WORLD WAR II MEMORIAL: FDR D-DAY PRAYER DESIGN DEVELOPMENT

APRIL 15, 2021

PRESENTATION TO THE
COMMISSION OF FINE ARTS

CFA 21/JAN/21-1

History and Overview | 2016 Placement within the Circle of Remembrance - Center Prayer Plaque Studies

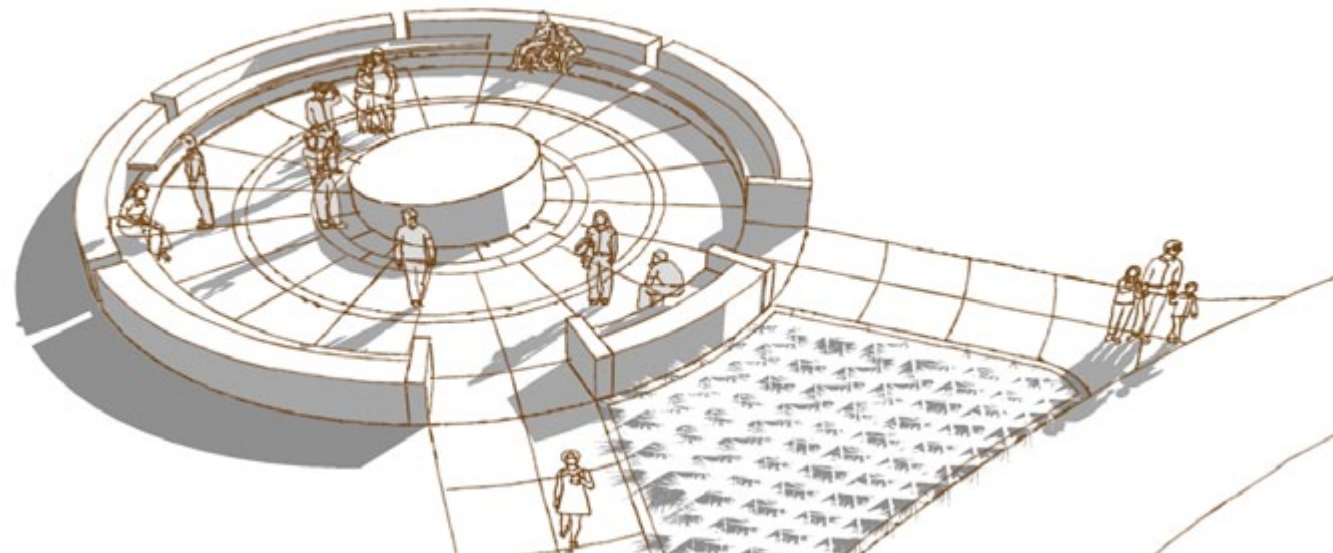
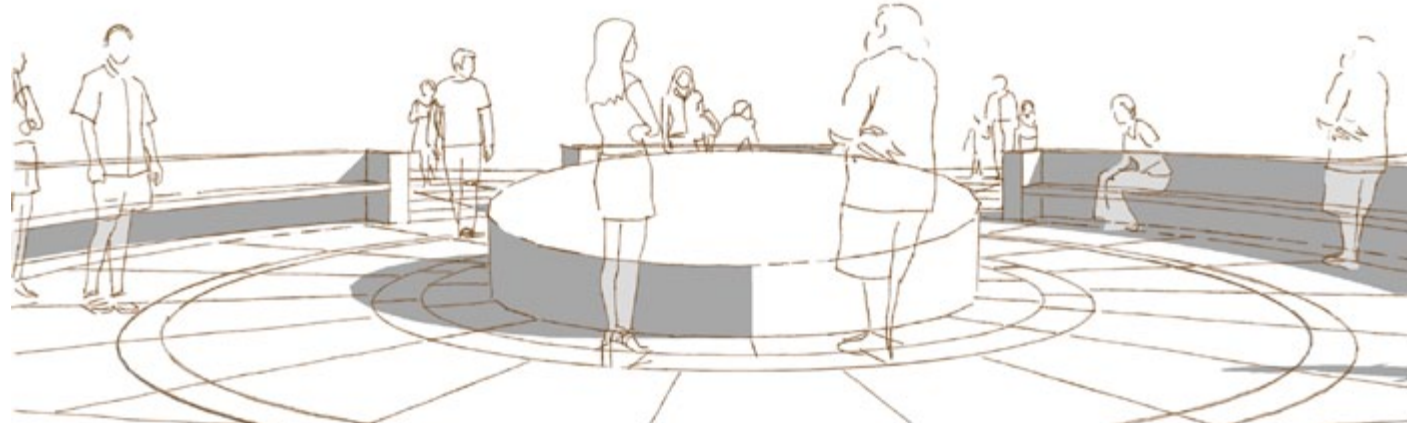
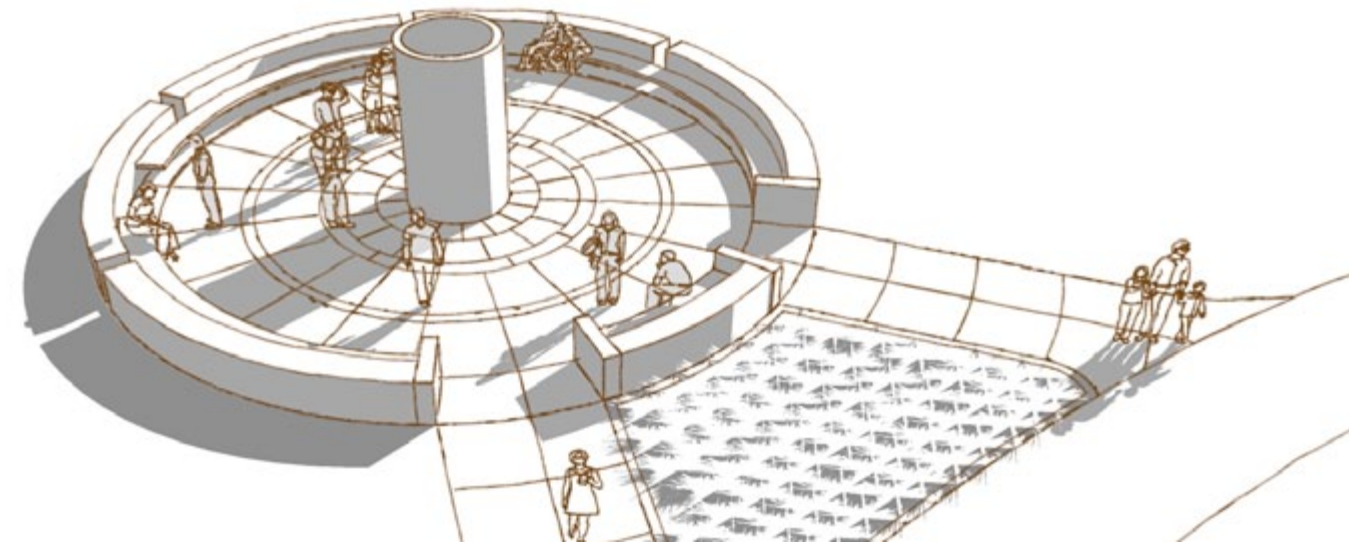
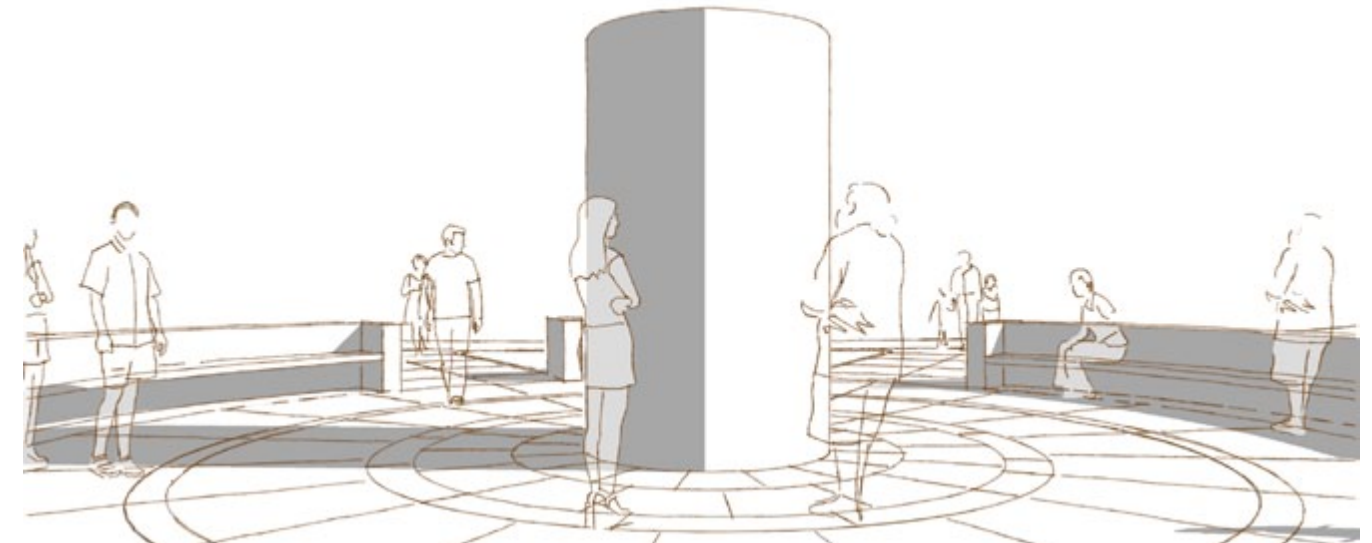
In previous review, Commission noted: *“The second alternative should explore a different location for the prayer text, away from the entrance, possibly in the geometric center, which is otherwise vacant.”*

- Center was studied during the siting process and was removed from consideration due to inability to meet design criteria
- Poor visual connection with WWII Memorial
- Incompatible with circulation and visitation patterns (annual D-Day gathering)
- Commission noted Plaque would be too large in the center of the Circle and advised studying other locations

While a central vertical element did not fit the design program, the revised submission includes a proposal for activating the center with a medallion

Prayer Plaque Preliminary Details

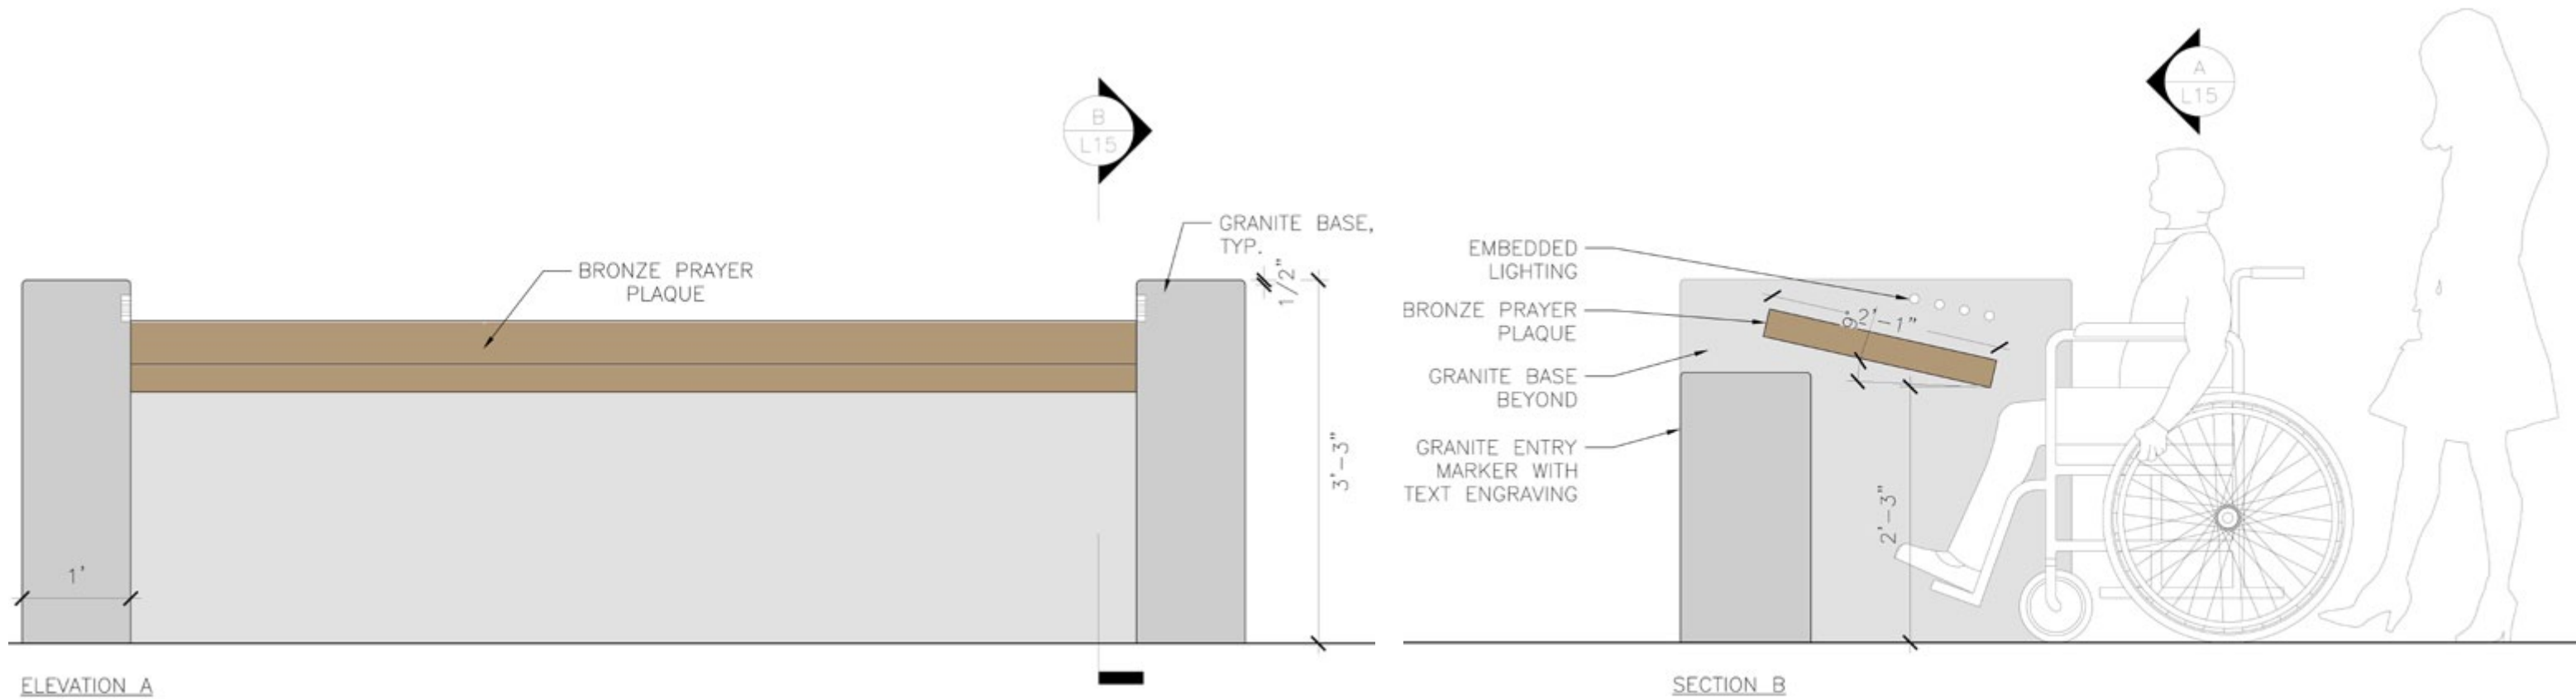
- **“a clear relationship to the larger composition of the World War II Memorial”**
- **“the plaque should be larger in scale to reinforce its significance”**
- **“enframing and support of the plaque be made more solid and substantial”**
- **“text in a pattern that reflects the gently curving geometry of the circle, and using a larger size of letters”**
- **“further study of the typeface”**
- **“explore a different location for the prayer... possibly in the geometric center...which is otherwise vacant”**
- **“the perimeter...could be less architecturally articulated”**

- Angle of plaque and height of granite base reduced to allow greater visibility into Circle
- Prayer Plaque 'floats' over granite base, repeating precedent set by granite benches
- Prayer Plaque lit from the sides

Precedent | Treatment of the Center

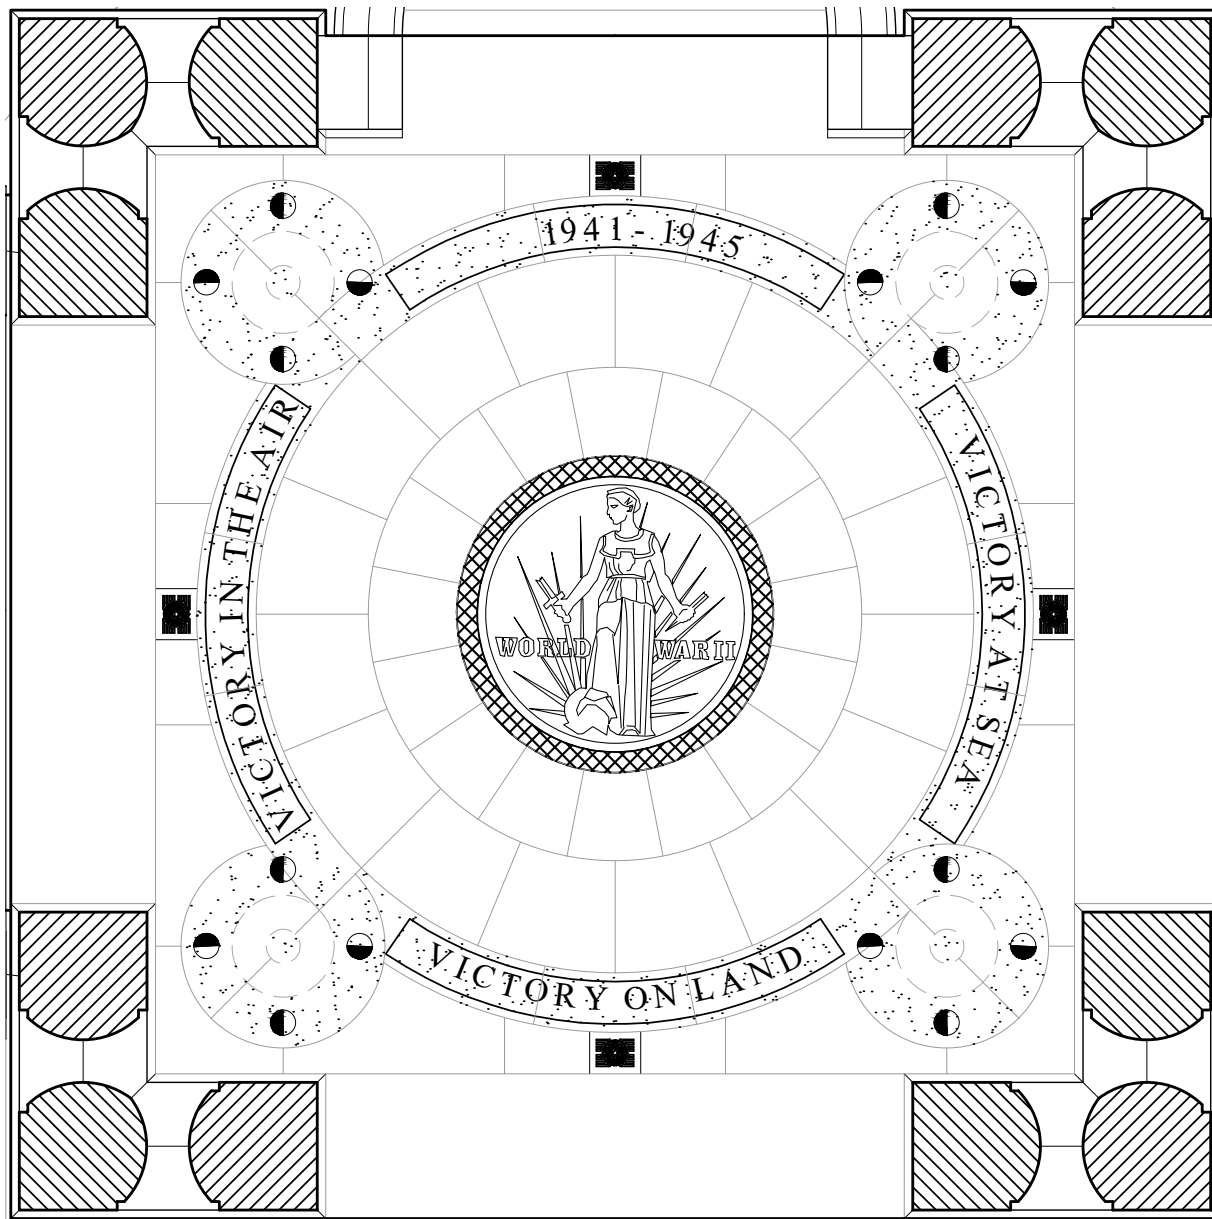
- In response to the Commission's comment regarding the Circle's 'vacant' center, a paving emblem is proposed
- WWII Atlantic and Pacific Arches provide inspiration for development of Circle's center paving design
- Bronze WWII Medal of Freedom, awarded to any veteran or civilian who performed a notable service
- Dark grey ring of 'Moss Green' granite with bronze inlay
